AGENDA ITEM 4C

**Conditional Use Permit – Hotel – Proposed Lot 2
Southport West Replat Nine – Cumming
Investments, Inc.**

**CITY OF LA VISTA
PLANNING DIVISION
RECOMMENDATION REPORT**

RE: Conditional Use Permit – Initial Review
Cumming Investments, LLC
Home 2 Suites – Southport West
Proposed Lot 2 Southport West Replat Nine

SITE PLAN CUP PLANS		REV. NO.	
SOUTHPORT WEST REPLAT NINE PUD PHASE 1			
			2022
		A, A

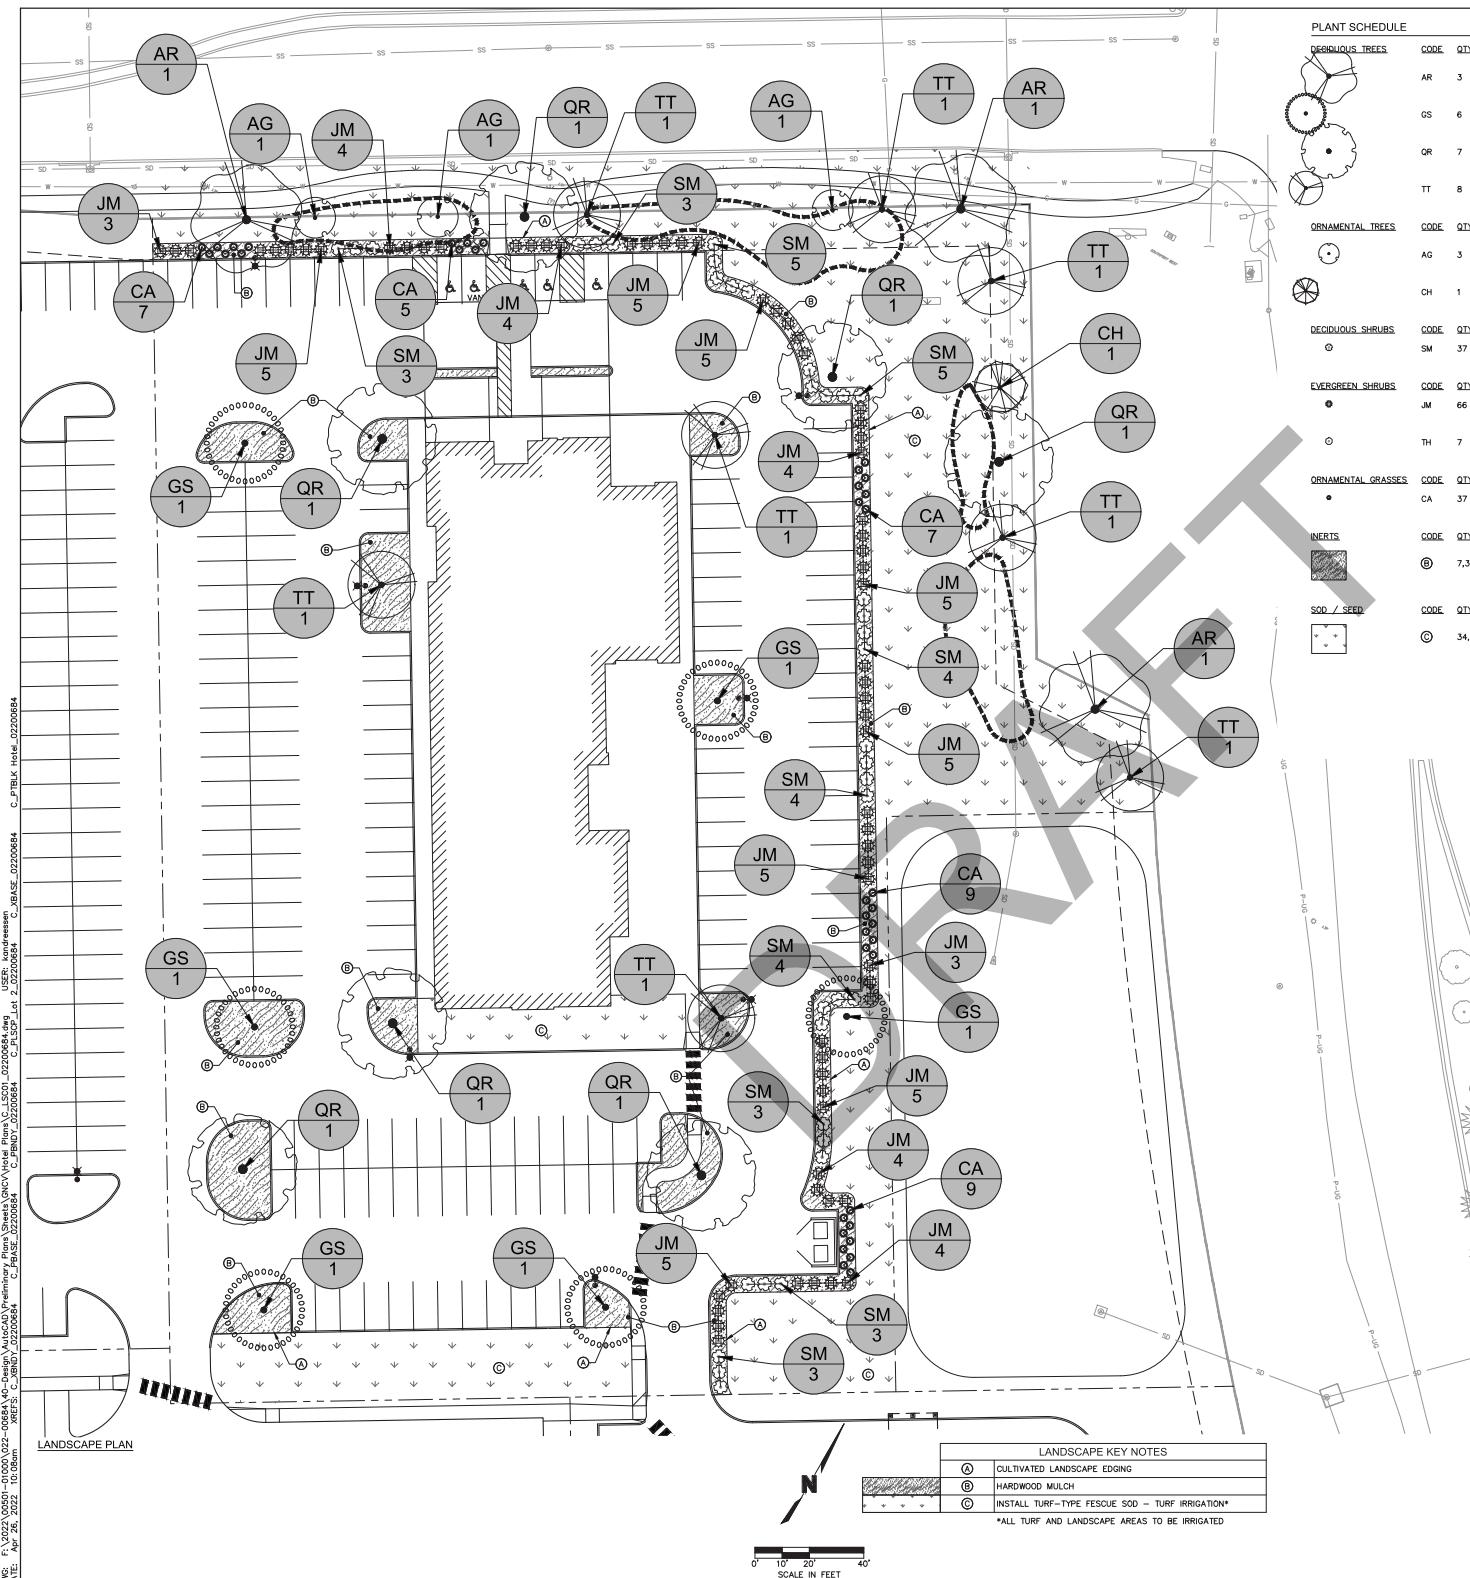
1. Per Section 6.05.01 and Section 6.05.04 of the La Vista Zoning Ordinance, Applicant needs to submit a site-specific CUP site plan package to be utilized as exhibits within the CUP presented to the Planning Commission and City Council. Specifically, the site plan should be centered on the hotel alone as it is the subject of the CUP.

This includes a full site plan, including locations of lights, structures, sidewalks/trails, and other aspects pertinent to this application. A copy of a similar CUP site plan has been attached as an example.

2. Per Section 6.05.01 and Section 6.05.04, please provide the height of the structure within the CUP site plan in feet as well as number of stories.
3. In regards to Section 6.05.01 and Section 6.05.04, the current site plan does not depict sidewalk connections to sidewalks along Southport Parkway. Please include these connections.

4. Per Section 6.05.05, the stall count for the subject property needs to be updated for the CUP only, including a breakdown of the ADA and ADA van stalls.

1. Per Section 6.05.01 and Section 6.05.04 of the La Vista Zoning Ordinance, Applicant needs to submit a site-specific CUP site plan package to be utilized as exhibits within the CUP presented to the Planning Commission and City Council. Specifically, the site plan should be centered on the hotel alone as it is the subject of the CUP.

2. Per Section 6.05.01 and Section 6.05.04, please provide the height of the structure within the CUP site plan in feet as well as number of stories.

3. In regards to Section 6.05.01 and Section 6.05.04, the current site plan does not depict sidewalk connections to sidewalks along Southport Parkway. Please include these connections.

4. Per Section 6.0F.05, the stall count for the subject property needs to be updated for the CUP only, including a breakdown of the ADA and ADA van stalls.

Response: Plan has been updated to include the information for this lot only.

Response: Structure height and stories have been updated based on discussions with the client.

Response: A sidewalk connection has been added to Southport Parkway

Response: Stall count has been revised for this lot only.

Exhibit D

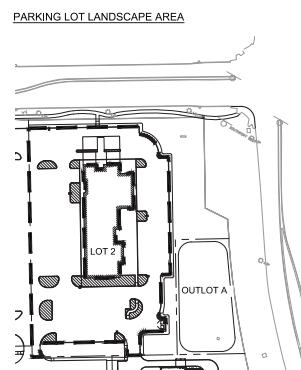
3. As stated previously, the site lies with the Southport West PUD, the development will need to proceed through the architectural design review approval process. The landscaping plan is currently under review by the City's third-party Design Review Architect. However, one aspect that needs to be addressed, even prior to the provision of a design review letter, is the lack of berming along Giles Road.

3. As stated previously, the site lies with the Southport West PUD, the development will need to proceed through the architectural design review approval process. The landscaping plan is currently under review by the City's third-party Design Review Architect. However, one aspect that needs to be addressed, even prior to the provision of a design review letter, is the lack of berthing along Giles Road

Response: Understood. We will work with developers to get these items submitted.
